Title: A/C Condensers for LT and RH Part Number Update

Applies To: LT and RH

This document will show the user the difference between original production and new A/C Condensers for LT and RH vehicles.

Condenser P/N 2516098C91 has been replaced with P/N 2518753C91, see images below:

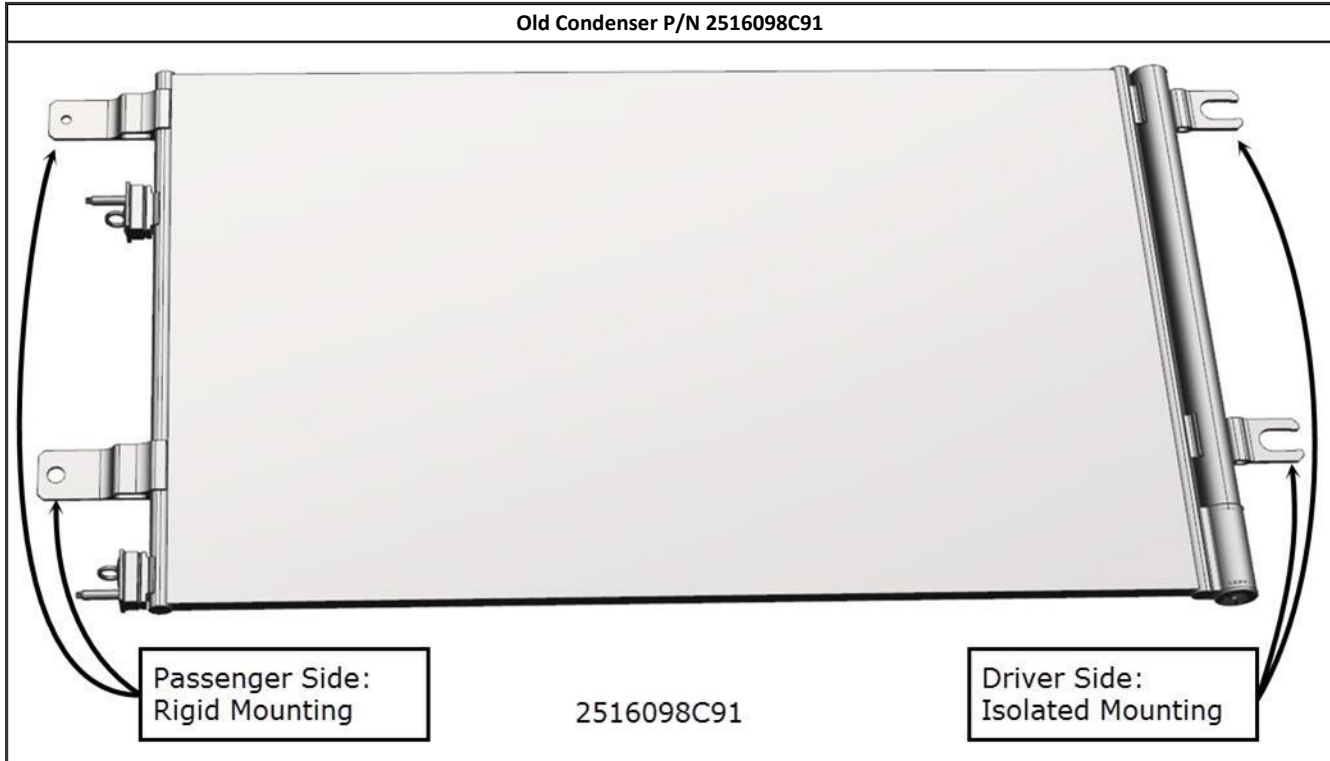
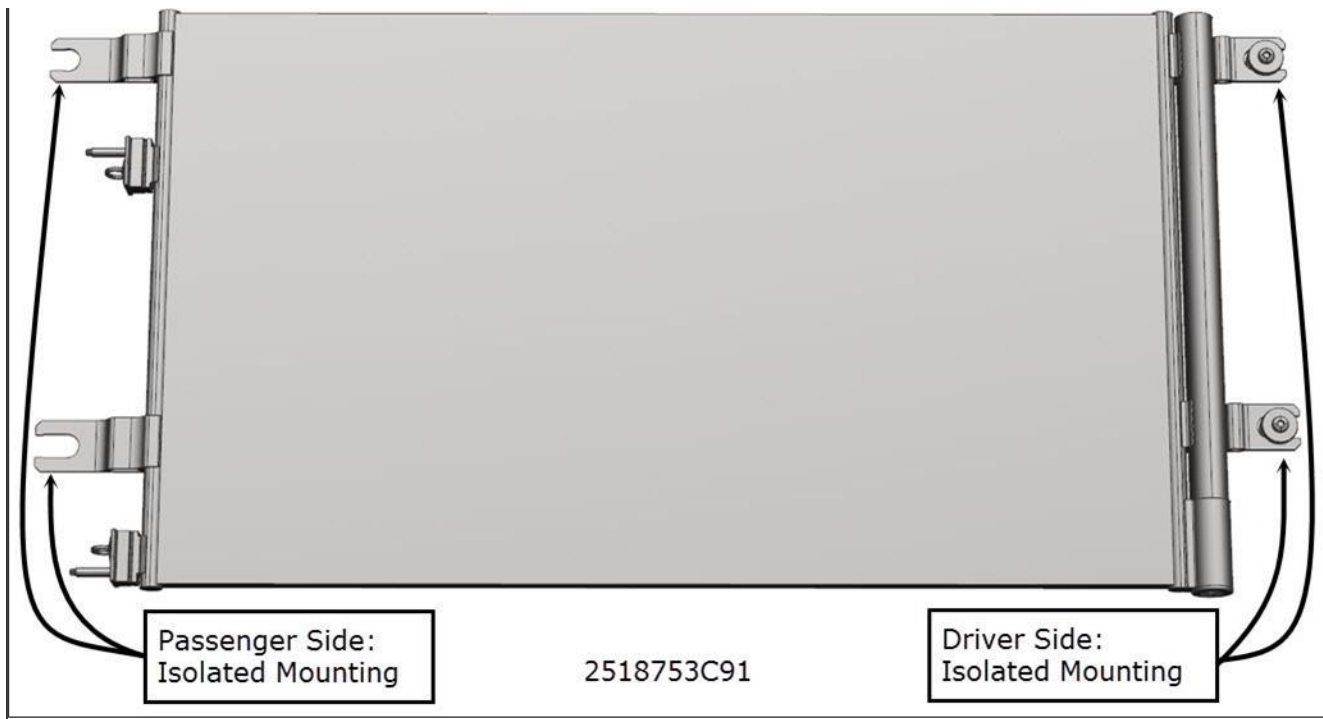
*4 isolators will come with the new condenser

The New Condenser can also be identified by the number of microchannels in the tubes
